In the Matter of	)	
	)	
SOUTHERN CALIFORNIA EDISON COMPANY	)	Docket Nos. 50-361
	)	and 50-362
(San Onofre Nuclear Generating	)	10 CFR § 2.206
Station, Units 2 and 3	)

DIRECTOR'S DECISION UNDER 10 CFR § 2.206

UNITED STATES NUCLEAR REGULATORY COMMISSION  
DOCKET NOS. 50-361 AND 50-362  
SOUTHERN CALIFORNIA EDISON COMPANY, ET AL.  
SAN ONOFRE NUCLEAR GENERATING STATION, UNITS 2 AND 3  
ISSUANCE OF DIRECTOR'S DECISION UNDER 10 CFR 2.206

Figure 1

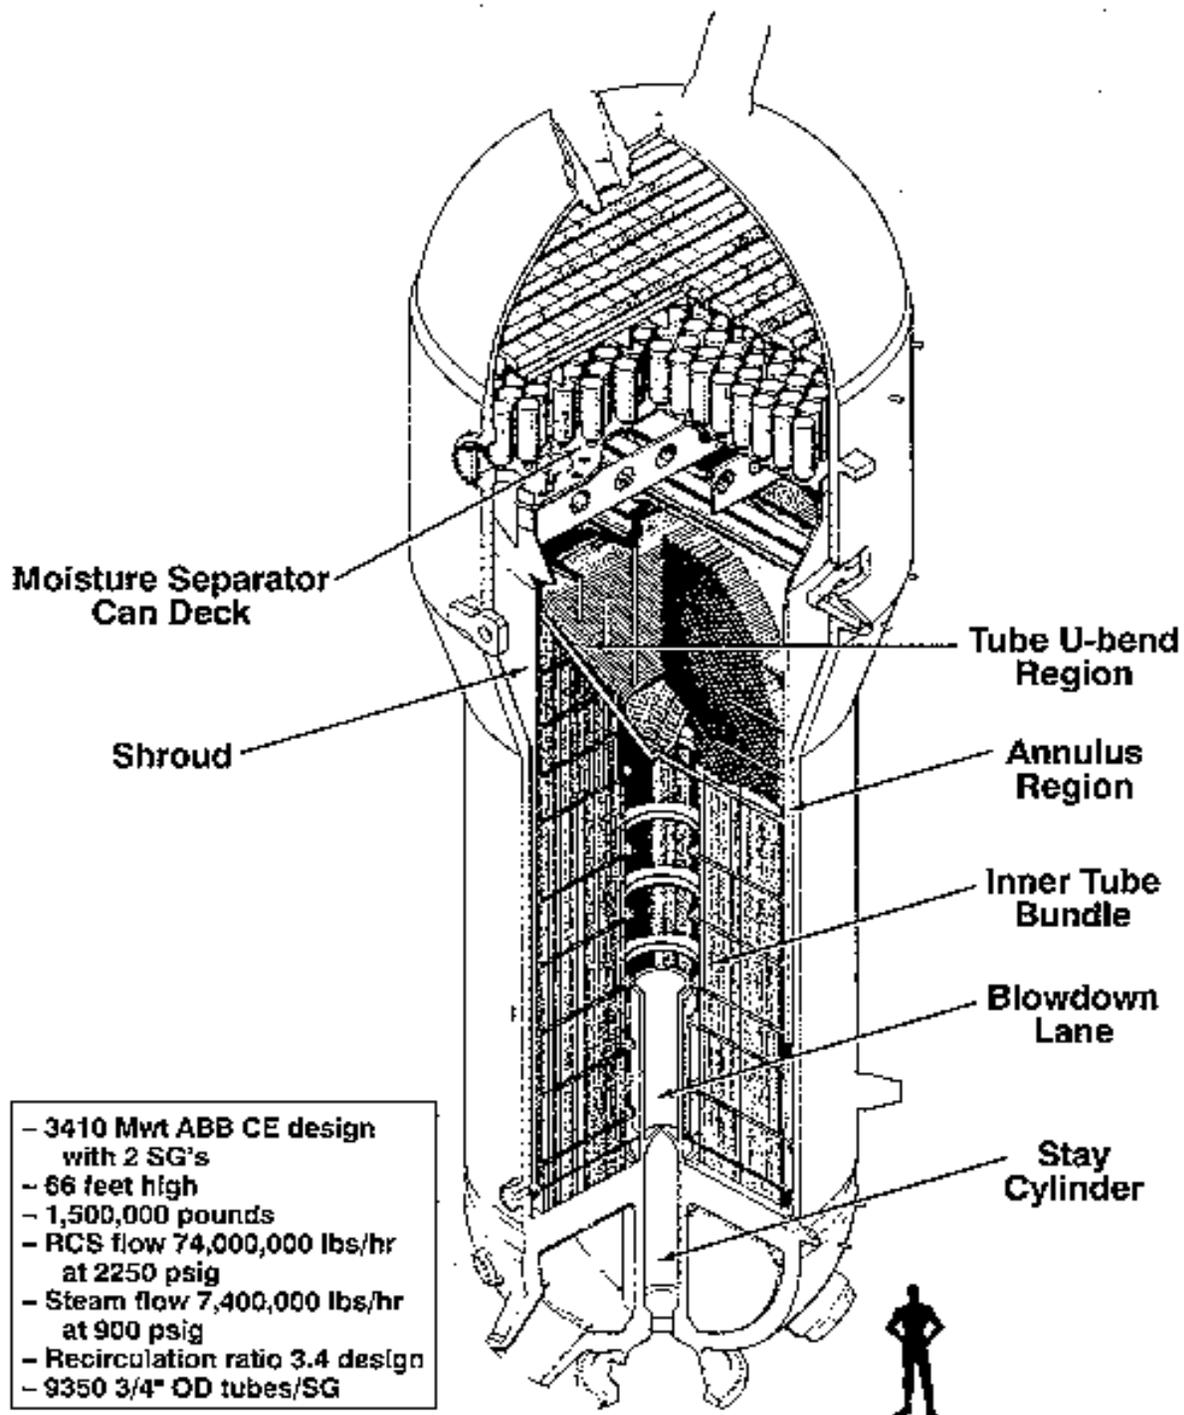
For the individual steam generator tube analysis, the licensee calculated the maximum loads that could occur assuming that adequate support was not available at two consecutive eggcrate levels (see Figure 1). The staff finds this assumption conservative and acceptable because the licensee has removed from service all tubes where two consecutive eggcrate levels were found degraded to the point where adequate support could not be assured.
